To: Development Permit Panel

File: DP 12-615424

Re: Development Permit DP 12-615424 – Follow-Up from September 26, 2012

STREETSCAPE - BLDG. 4 ALDERBRIDGE WAY
SCALE 1/8" = 1'-0"

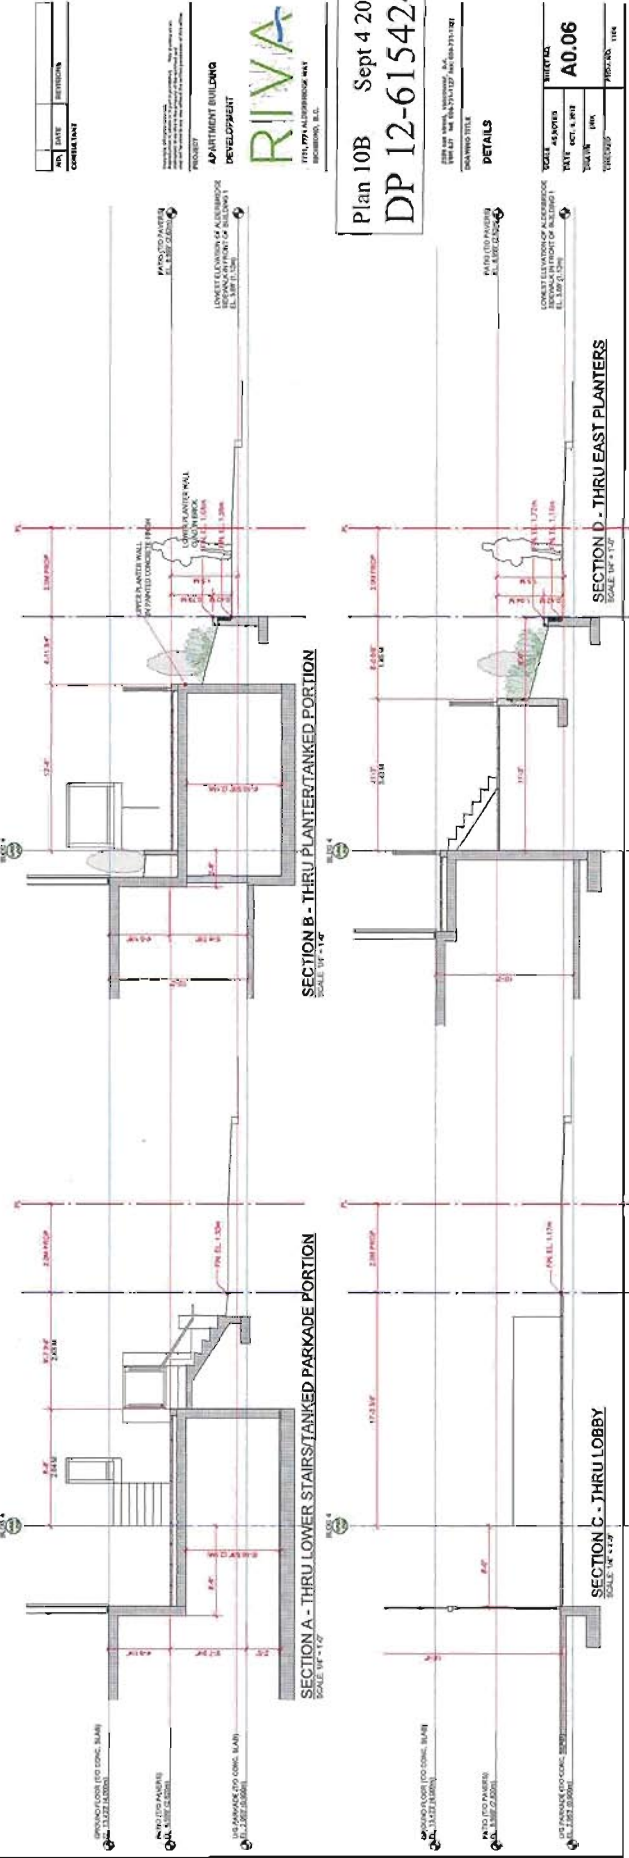
The applicants have worked to change the Alderbridge Way frontage conditions to address concerns from the DP Panel. The applicants have also provided further enlarged sections along Alderbridge Way (Buildings 1 and 4), Cedarbridge Way (Buildings 1 and 2) and also River Road (Buildings 2 and 3) to better illustrate the street edge conditions with the requested changes. Specifically, as requested, the applicants have made design changes to Alderbridge Way and Cedarbridge Way edge conditions for Buildings 1 and 4 (Amended DP Plans 10A, 10B, 11C to 11G, 48 and 51) as follows by:

- Ensuring that all of the patio terraces do not exceed 1.5m (4.9 ft.) above the adjacent public sidewalks along Alderbridge Way. This was achieved, in part, by lowering the slab elevation of the covered bicycle parking at the front edge of the building in relation to the adjacent covered vehicle parking area;

- Reducing the height of the landscape wall adjacent to the Alderbridge Way sidewalk from 0.75m (2.5 ft.) down to 0.45m (1.5 ft.) (seat height);
- Stepping the lower landscape wall in an increased number of places adjacent to Cedarbridge Way that more closely mirroring the change in the elevation of the street;

- Including sloped landscaping between the lower walls adjacent to the sidewalk and the upper walls adjacent to the patio terraces to reduce the apparent height of the higher wall;

- Lowering, pushing back and further angling the corner sections of these retaining walls from the public sidewalk at the intersections of Alderbridge Way with: the North-South Greenway on the western side of the site, Cedarbridge Way at the middle of site and the East Lane;

- Significantly improving the location and the stairs leading from the Alderbridge sidewalk to several of the units.

STREETSCAPE - BLDG. 3 RIVER ROAD
SCALE: 1/4" = 1'-0"

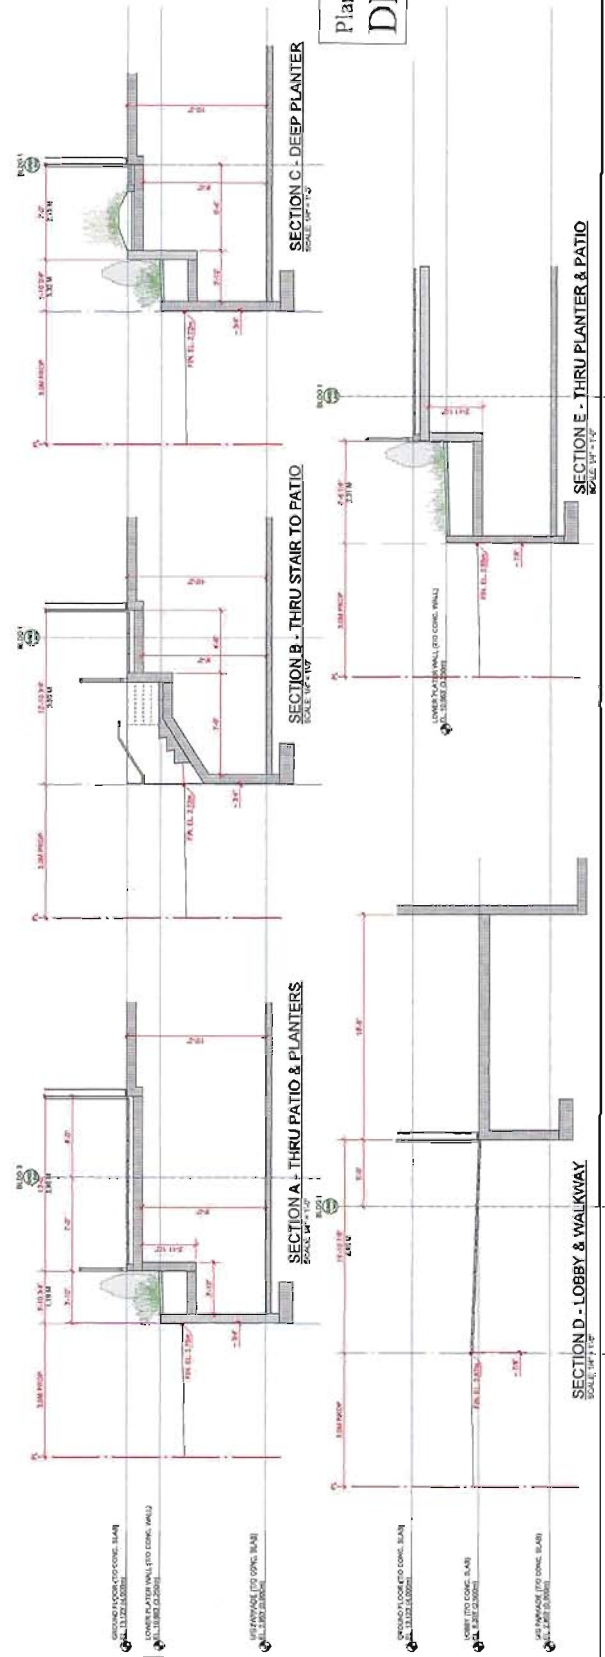
Also, as requested by staff, the applicants have made design changes to the River Road edge conditions for Buildings 2 and 3 (Amended DP Plans 11A and 11B) as follows by:

PROJECT NO. 12-615424
SHEET NO. A3.04

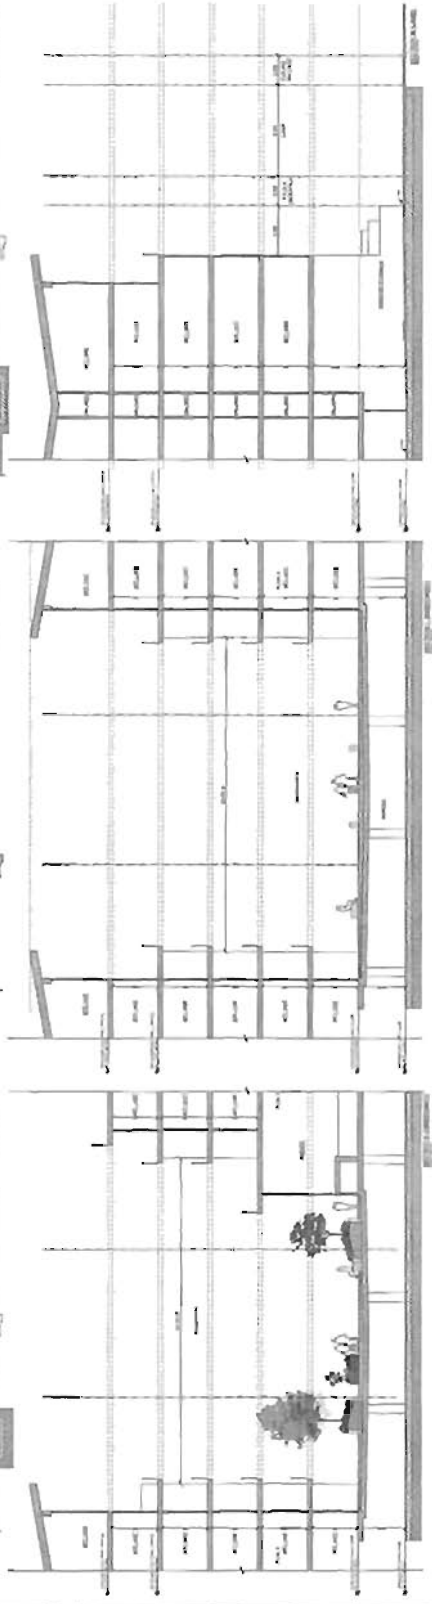
Similar adjacent terraced planter walls are located between Building 2 and the Gilbert Road allowance property line on the proposed Lot 1 (see Architectural plans A3.04 and A3.06). There will be approximately 20 m (66 ft.) of slightly lower open space between the project property line and the future curb line within the Gilbert Road allowance. As discussed below in this report, the City will be constructing a plaza, pedestrian and cycling paths and locating a major public art work adjacent to this property line within the Gilbert Road allowance. This area will be raised to the level of Gilbert and River Roads which at a similar level to the base of the project's landscape walls which are located in front of the parkade.

(Staff supports the proposed variance for the parkade wall and interim retaining wall under Buildings 1 and 2 on the west side of the proposed Lot 1. The proposed retaining wall and parkade wall range from 0.0 m to approximately 2.5 m (8.2 ft.) in height above grade see Architectural plans A3.04 and A3.06).
